Southern Nuclear Operating Company
Vogtle Electric Generating Plant Unit 3
Preliminary Amendment Request (PAR):
Basemat Concrete/Rebar Details (PAR-12-007)

**Preliminary Amendment Request
Regarding
Basemat Concrete/Rebar Details**

Preliminary Amendment Request (PAR-12-007): Basemat Concrete/Rebar Details

Licensing Basis Document Proposed Changes

UFSAR Figure 3H.5-3 (Partial)

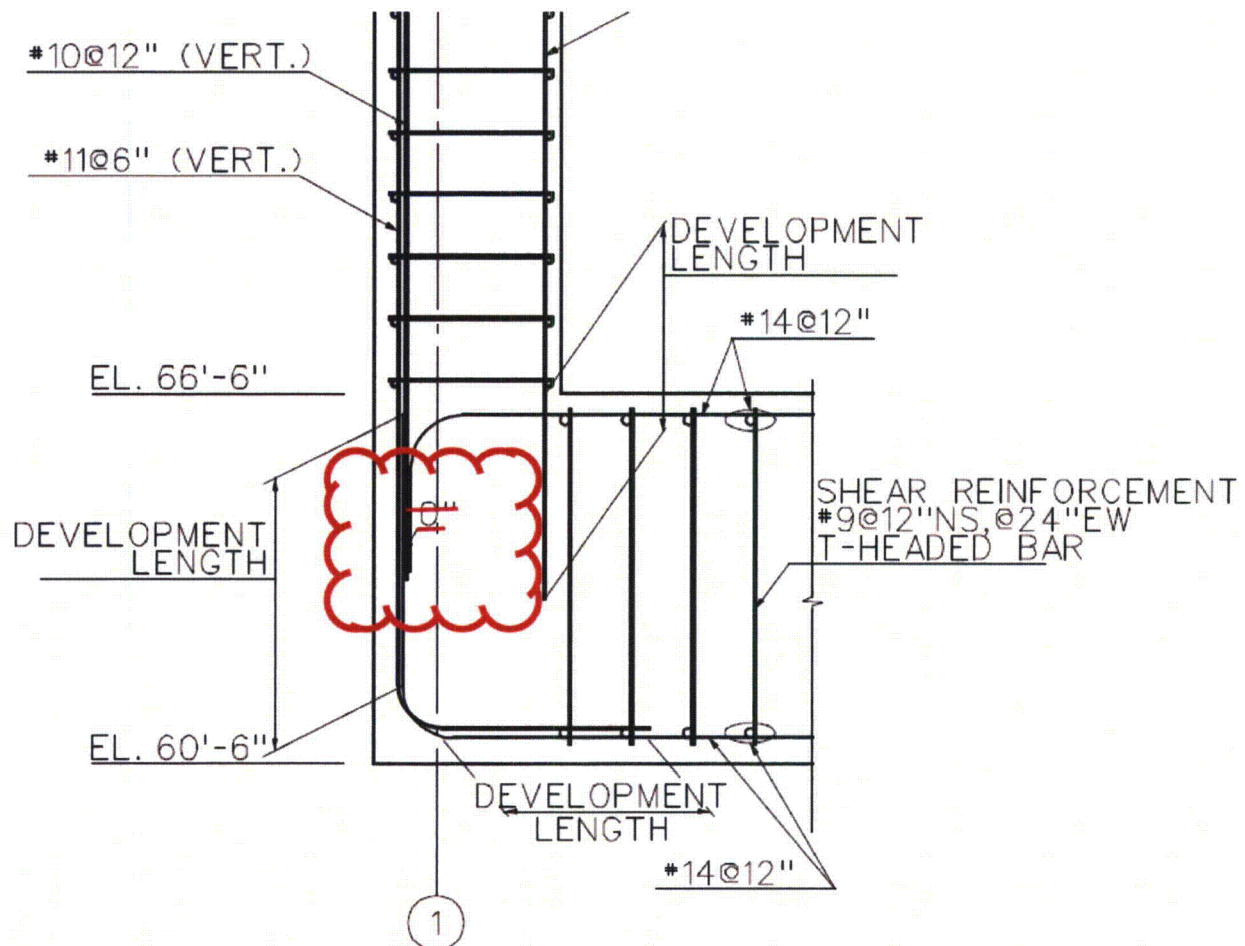
In the Lower-Section detail of Figure 3H.5-3 that represents the basemat below the exterior wall, the 0" dimension is removed.
